# UNITED STATES PATENT AND TRADEMARK OFFICE

**Office Action Summary**

10/521,541

## **DETAILED ACTION**

**Figure 1: Johnson, US 3,242,769**

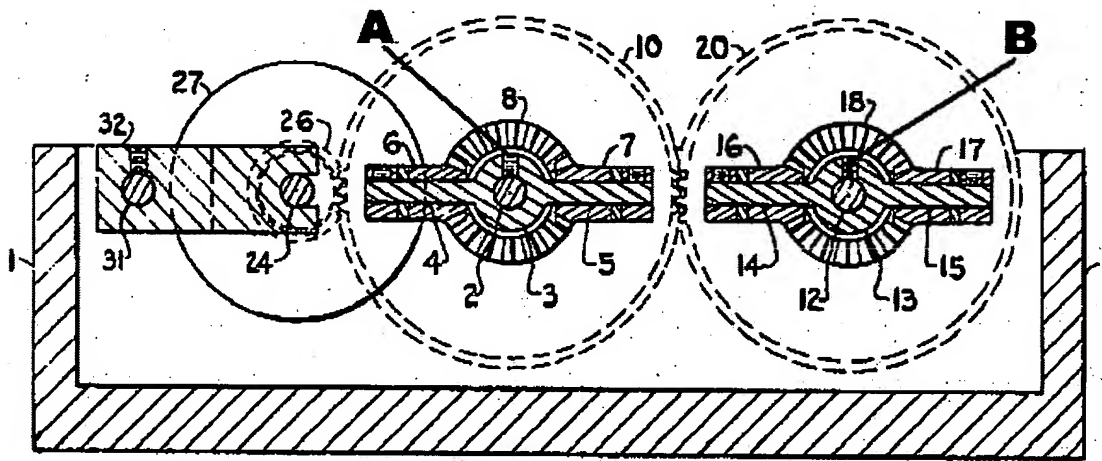
Johnson shows in figure 2 a transmission comprising a main shaft (3) and an auxiliary shaft (13), each formed with a shaft groove in the center, (shown in figure 1 below by reference letters (A, B), which have been added by the examiner), and hollow parts pointed out by reference numbers (2, 12), control gears (6, 7, 16, 17) having power distribution elements (teeth), a control casing (1) having control levers (38), first to fourth ring gears (10, 11, 20, 21) having a transmission rate (gear ratio) as transmission varying elements, first to fourth side gears (8, 9, 18, 19) attached to the ring gears, and first (26) and second (29) idle gears, wherein a casing (1) supports the main shaft (3) and auxiliary shaft (13), and the first (26) and second (29) idle gears.

The grooves (A, B) formed in the centers of the main shaft and the auxiliary shaft are positioned on a same line with the control gear shafts which are orthogonal to the main and auxiliary shafts.

On one side, the main shaft and the auxiliary shaft are engaged with the first (10) and third (20) ring gears, along with the first idle gear (26), representing a low speed gear ratio and, on the other side the main shaft and the auxiliary

shaft are engaged with the second (11) and fourth (21) ring gears, along with the second idle gear (29), representing a high speed gear ratio. The first (10) and third (20) ring gears are engaged with the first (8) and third (18) side gears to be engaged with the control gears (6, 7, 16, 17). The second (11) and fourth (21) ring gears are engaged with the second (9) and fourth (19) side gears to be engaged with the control gears (6, 7, 16, 17).

Johnson does not teach unidirectional clutches being provided on both sides of the main shaft and the auxiliary shaft.
